Detailed Site Plan DET-2024-010
Enclave at Brandywine, Phase 2

REQUEST	STAFF RECOMMENDATION
Development of 36 townhouse dwelling units and associated infrastructure.	With the conditions recommended herein: • APPROVAL of Detailed Site Plan DET-2024-010 • APPROVAL of Type 2 Tree Conservation Plan TCP2-2025-0089

SUBJECT: Detailed Site Plan DET-2024-010
Type 2 Tree Conservation Plan TCP2-2025-0089
Enclave at Brandywine Phase 2

TAX MAP: 154, E4	ZONING CATEGORY: RSF-A
WSSC 200' SHEET: 220SE06 & 220SE07	
SITE DATUM HORIZONTAL: NAD83 VERTICAL: NGVD29	
1" = 30'	DATE: APRIL 2025
SHEET 4 OF 5	DESIGNED: DJB TECHNICIAN: DJB CHECKED: DJB CAD STD'S. VERSION: V8 / NCS
PROJECT NO. 3844-00-00

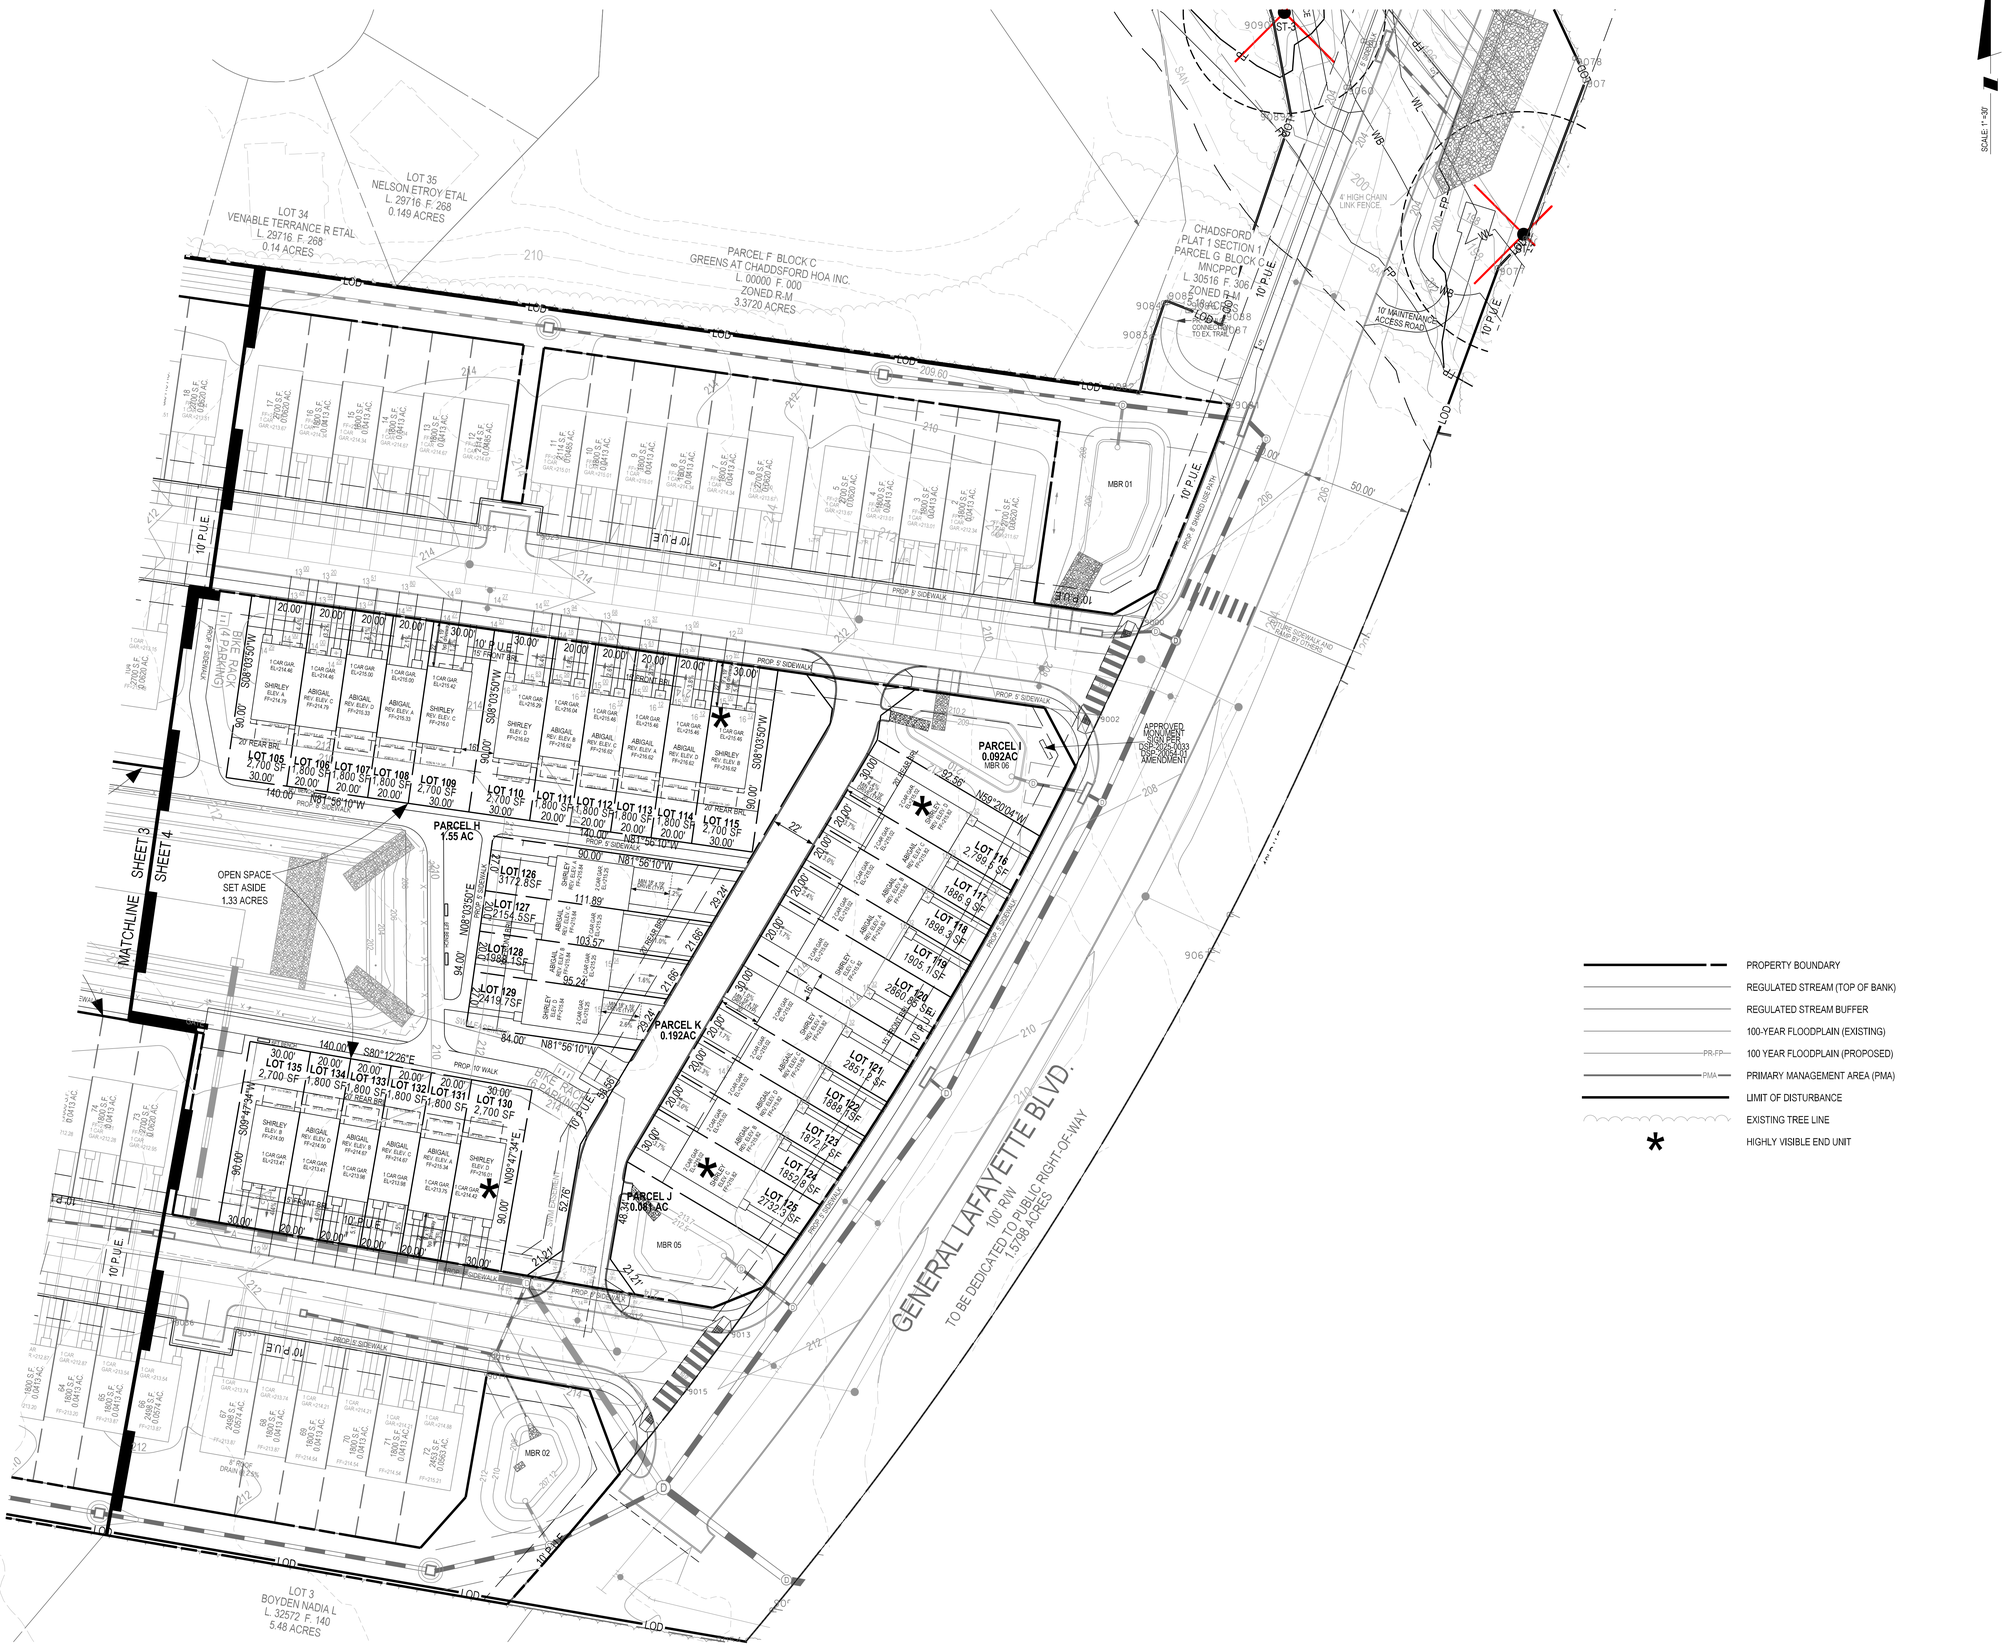
The proposed facilities meet the intent of the policy. However, the striped bicycle lane is not shown on Sheet 4 of the DET, which is conditioned herein to be included.

f. Show the striped bicycle lane on Sheet 4 of the DET.

TAX MAP: 154, E4	ZONING CATEGORY: RSF-A
WSSC 200' SHEET: 220SE06 & 220SE07	
SITE DATUM HORIZONTAL: NAD83 VERTICAL: NGVD29	
1" = 5'	DATE: APRIL 2025
	DESIGNED: DJB
	TECHNICIAN: DJB
	CHECKED: DJB
SHEET 5 OF 5	CAD STD'S. VERSION: V8 / NCS
PROJECT NO. 3844-00-00

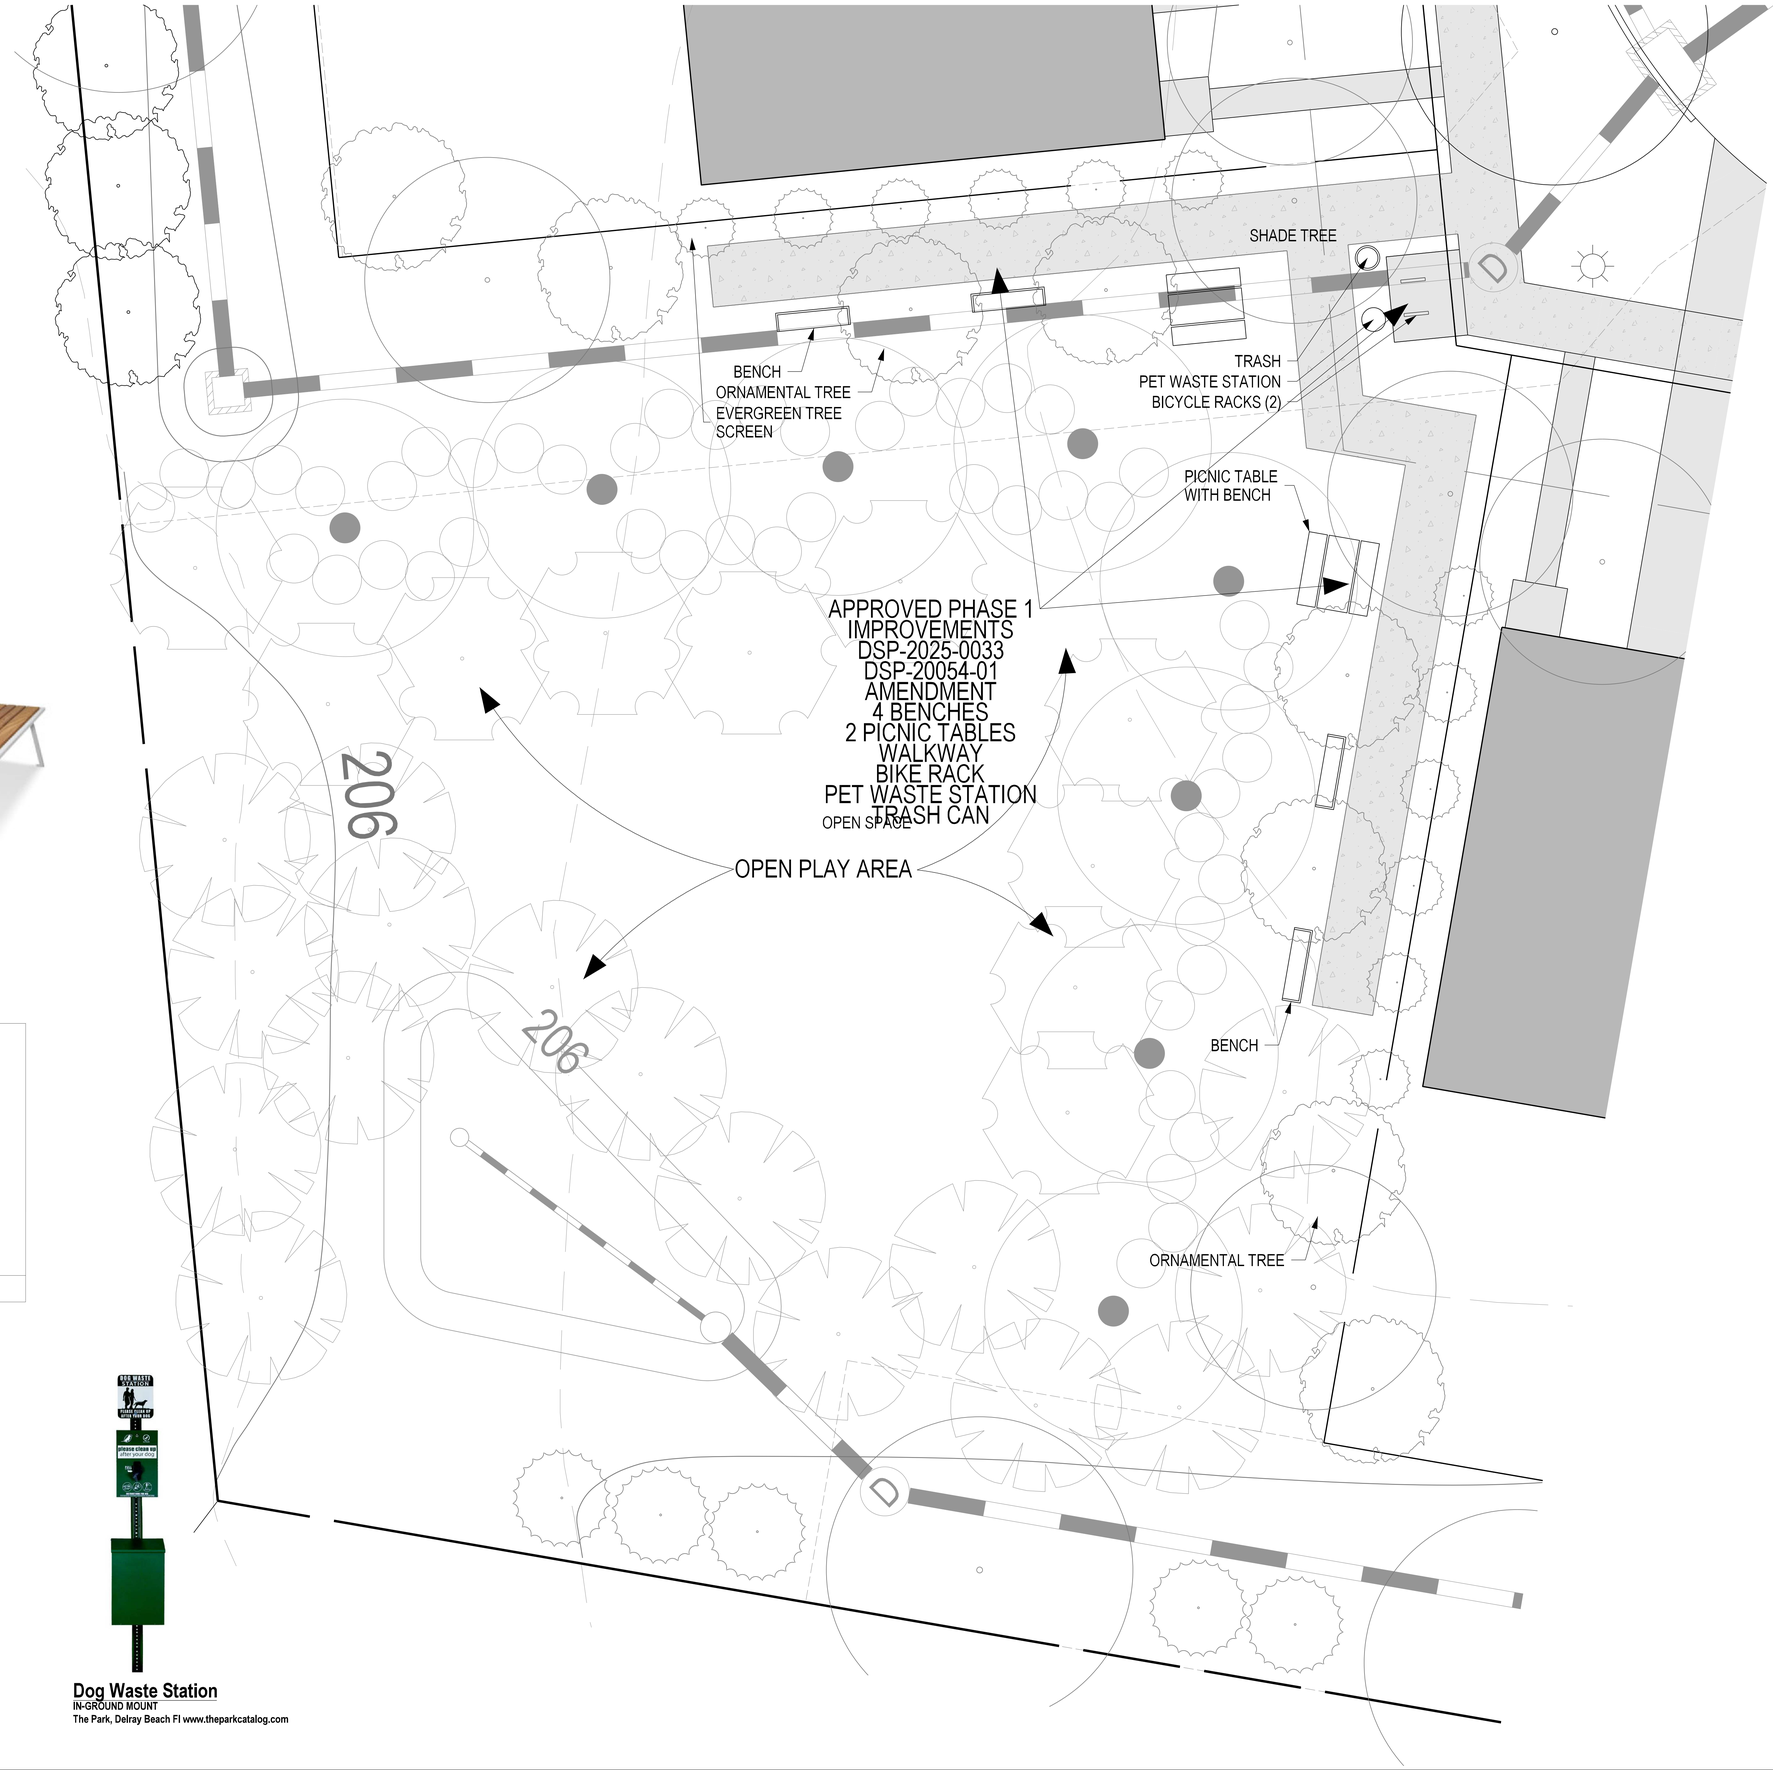
Details for the open play area in Parcel G are included in Sheet 5 of the DET. The plan shows four proposed benches, two picnic tables, one pet waste station and one trash receptacle. The detailed plan is consistent with the improvements shown in DSP-2025-0033 for Phase 1. The subject DET will supersede DSP-2025-0033 for improvements in the open play area.

TYP. SIDE ELEVATION – LOT #136
SHIRLEY (22’ UNIT) – ELEVATION ‘D’

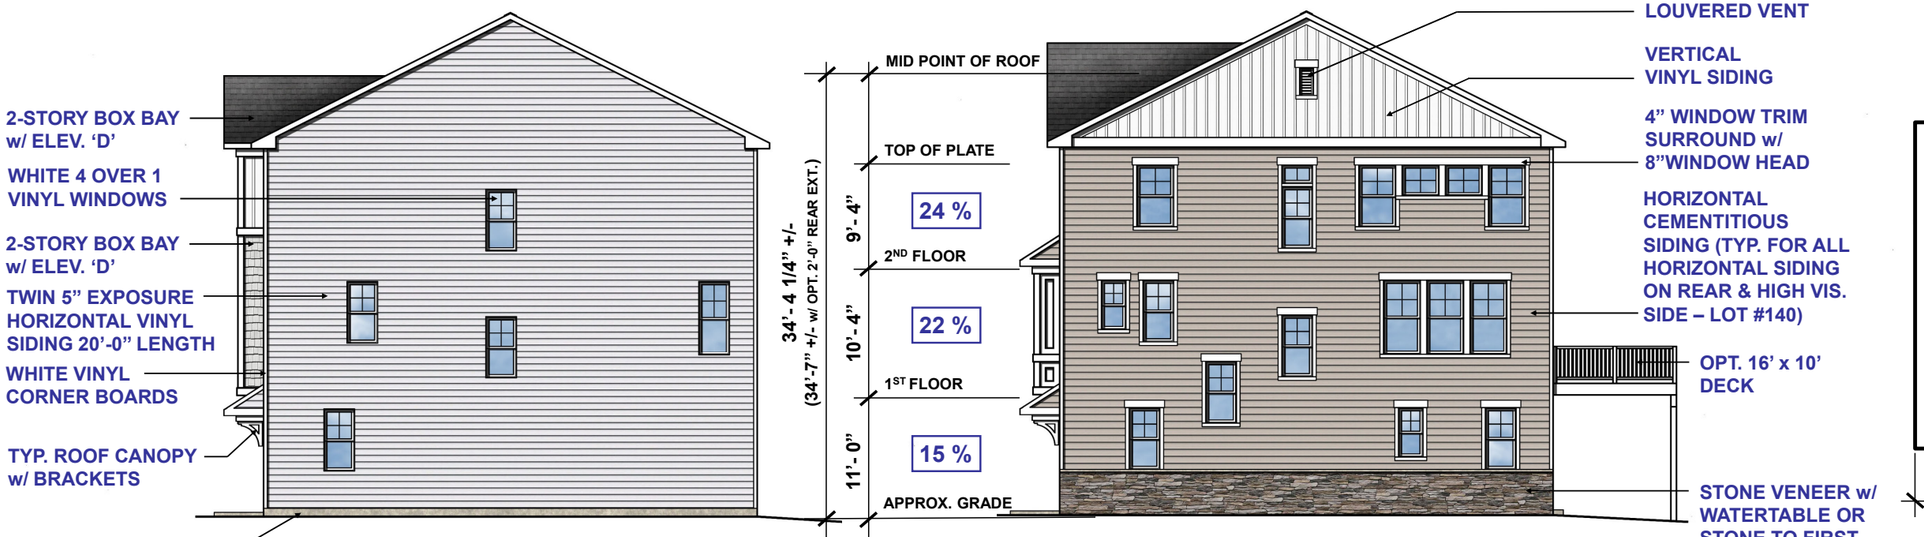
As shown on Sheet 10 of the submitted architecture elevation, and in the exhibit on page 103 of the submitted SOJ, the proposed rear and side façade demonstrates conformance to the transparency standards in Table 27-61203(d)(1). However, the percentage is not labeled on the architectural elevation on Sheet 10. A condition is included to label transparency percentage to the rear elevation for Lots 136–140 in architectural elevation package.
